TM 11-6625-274-35

TEST SETS, ELECTRON TUBE TV-7/U,
TV-7A/U, TV-7B/U, AND TV-7D/U

CHANGE }
No. 5 }

CHANGE }
No. 4 }

Figure 44(1). Test Set, Electron Tube TV-7D/U, schematic diagram (sheet 1).

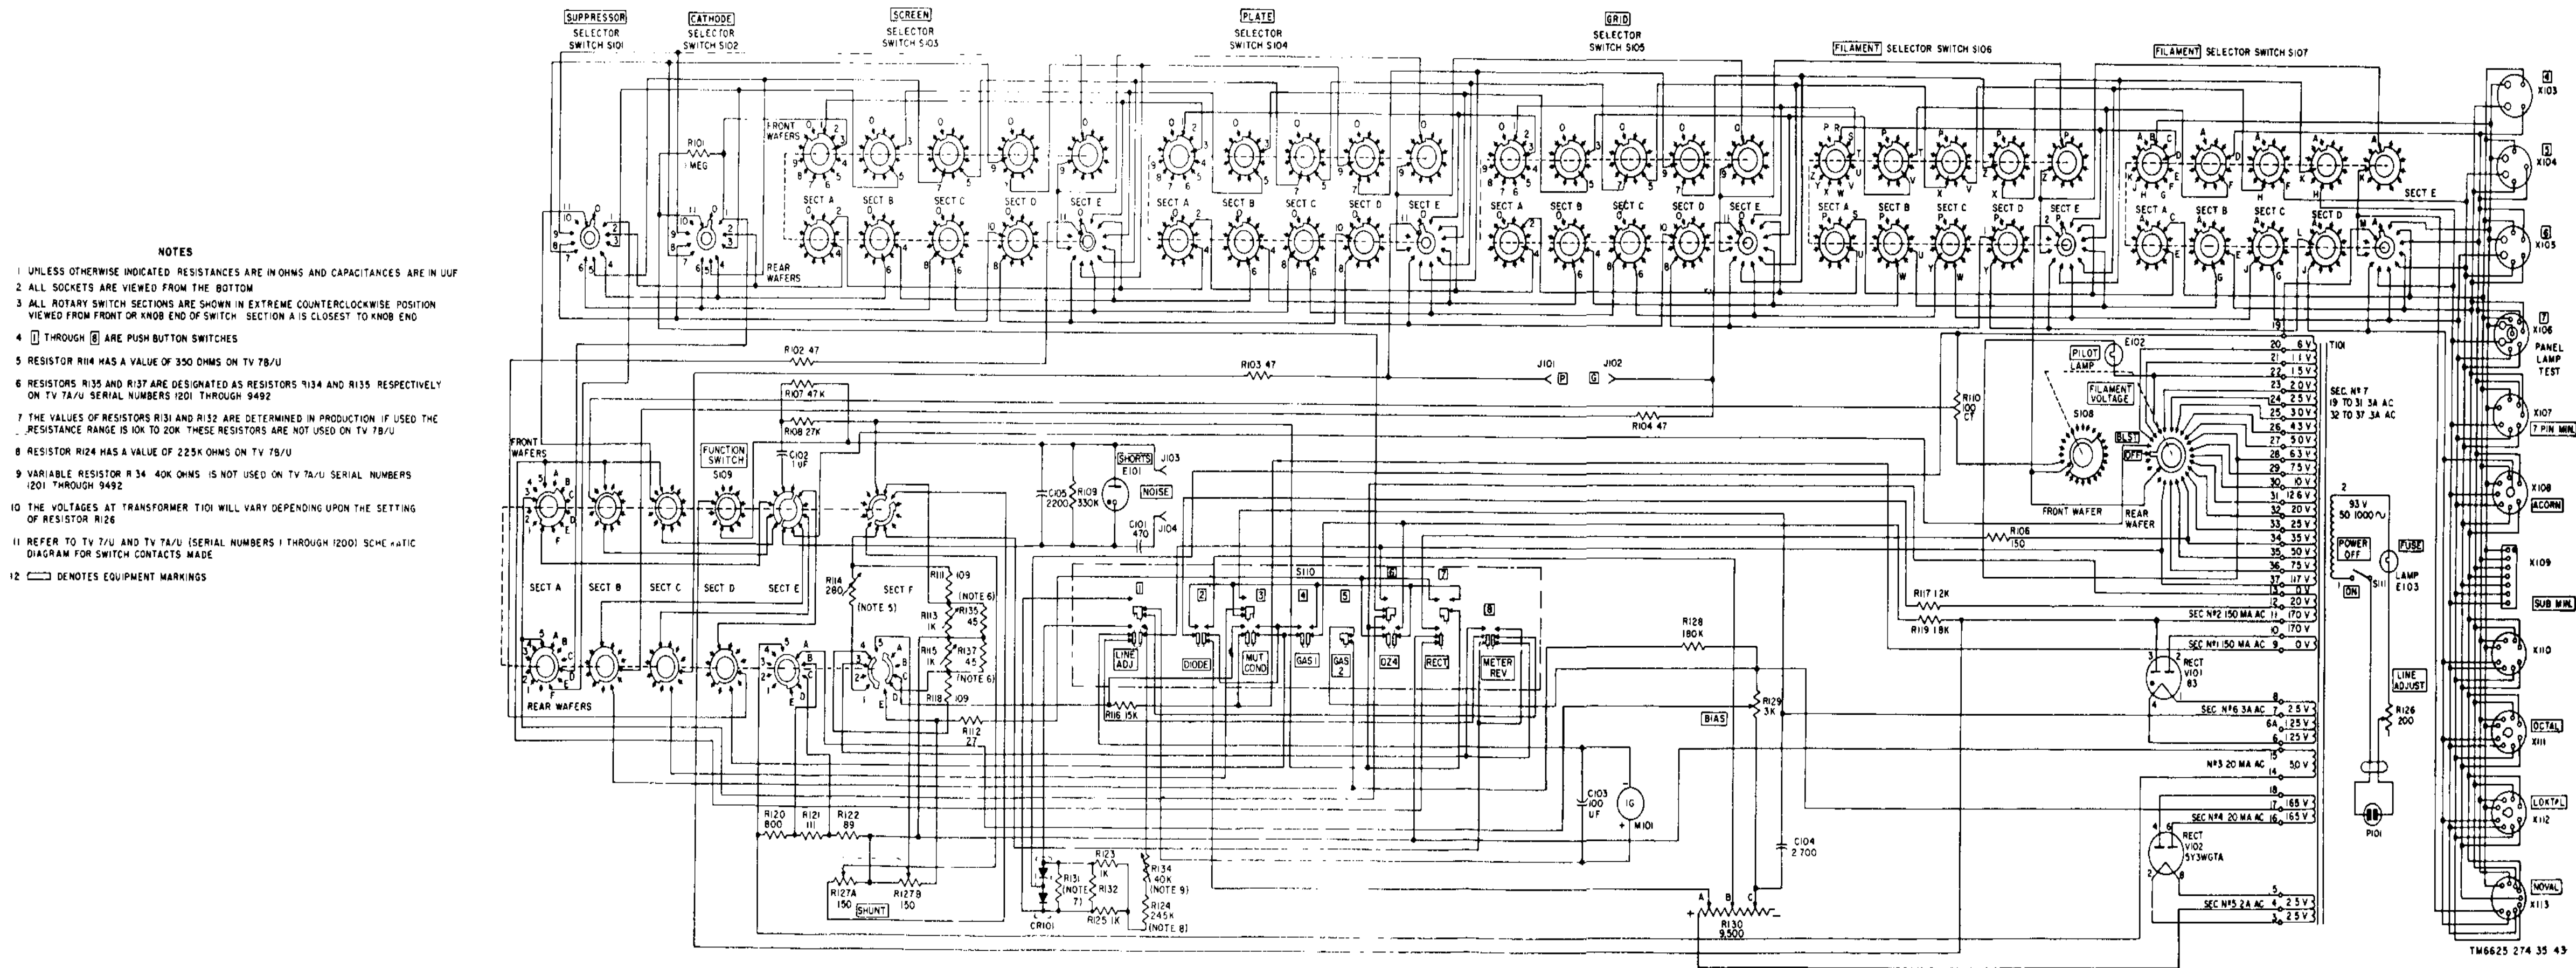
Figure 44② (sheet 2), switch S109, section F. Delete the connection between contacts D and E and substitute 2 connections between C and E.
